**ADDENDUM  
NO. 3**

**October 11, 2024**

**Whiteland High School Ph 2: Café Kitchen Band Choir Auditorium**  
**300 E. Main Street**  
**Whiteland, IN 46184**

6 AUDITORIUM STAGE AV RACK ELEVATION N.T.S.

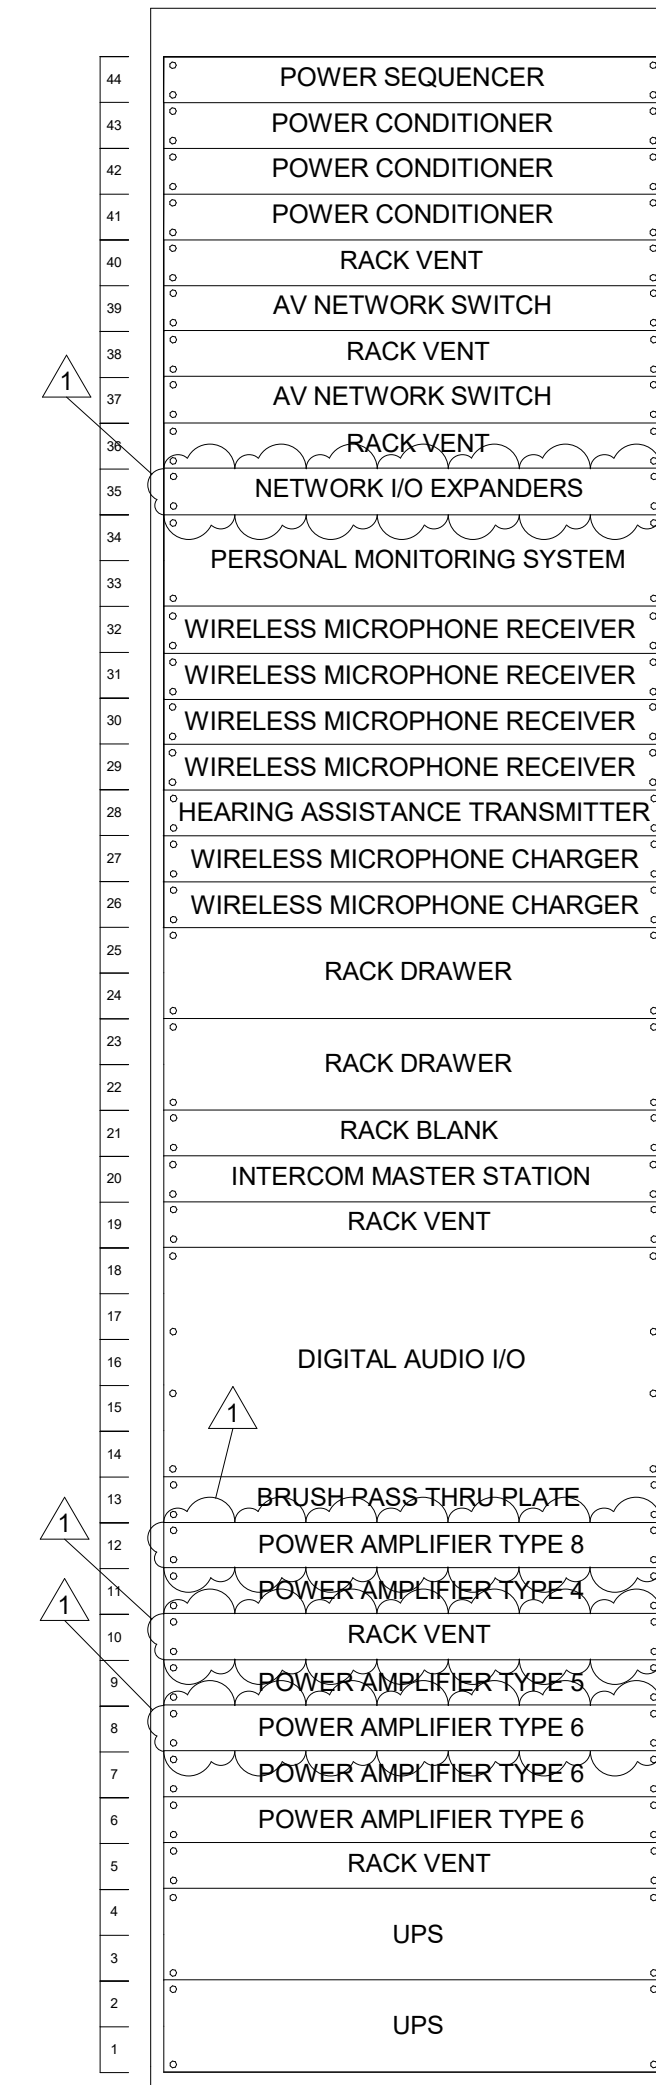
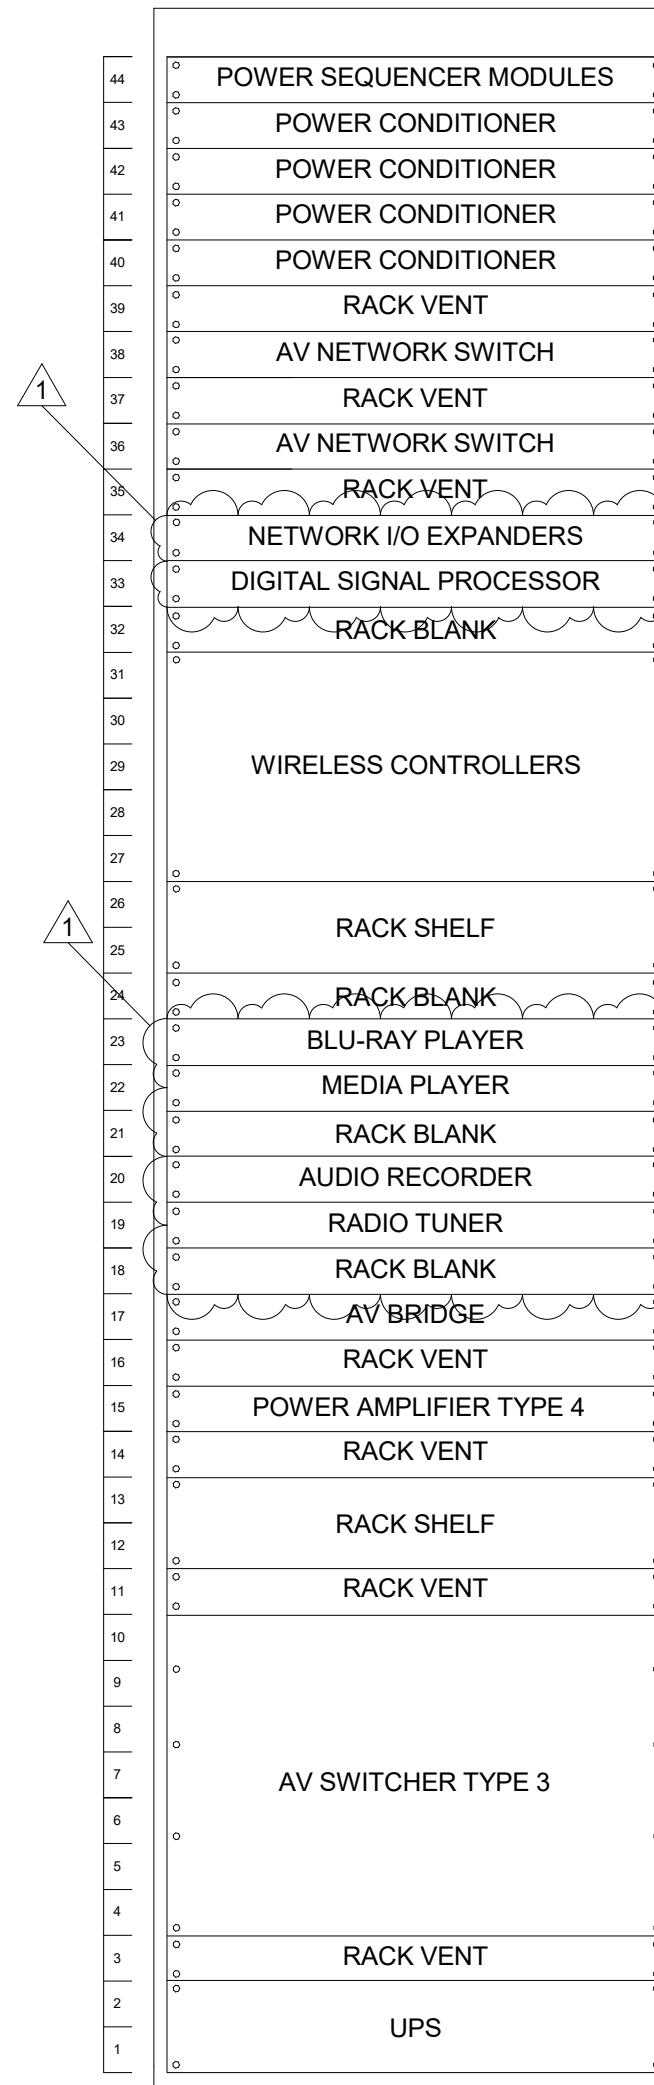
- a. AV rack elevations formerly placed on Sheet 320 are now placed on new Sheet 321
- b. Removed digital signal processor type 2 from the stage AV equipment rack and added it to the IDF P102e AV equipment rack
- c. Updated power amplifier spacing according to manufacturer recommendations
- d. Updated the stage monitor power amplifier type to new power amplifier type 8
- e. Removed 1 RU of network I/O expanders from the IDF P102e AV equipment rack and added digital signal processor type 2
- f. Removed 1 RU rack blanks between the audio recorder and radio tuner and the blu-ray player and media player
